STAFF REPORT: OCTOBER 9, 2024, REGULAR MEETING

APPLICATION NUMBER: HDC2024-00490

ADDRESS: 15035 GRANDVILLE

SCOPE: REPLACE WOOD WINDOWS WITH VINYL WINDOWS

September 2024 photo by staff.

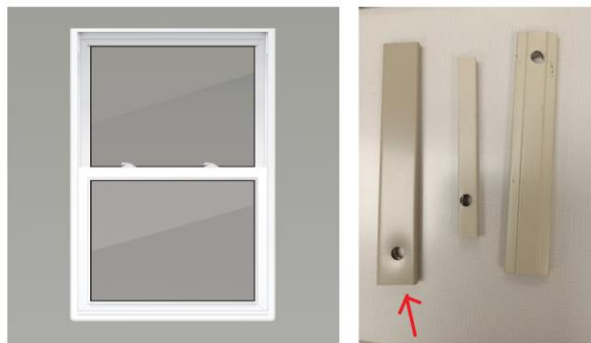
Some changes to the building have been made in recent decades, with no record of approval by the Historic District Commission. Shutters, apparently original and most likely wood, have been replaced by slightly

smaller vinyl shutters. This work was done between 2013 and 2018, according to Google Maps image. Sometime between 2007 and 2013, large dentils beneath the roofline and downspouts with prominent collector boxes once existed, both details commonly associated with Colonial Revival architecture and important to the character of the building, were removed. Finally, the entrance pilasters, with capitals, and pediment with distinctive dentil work, were covered in what appears to be vinyl or aluminum.
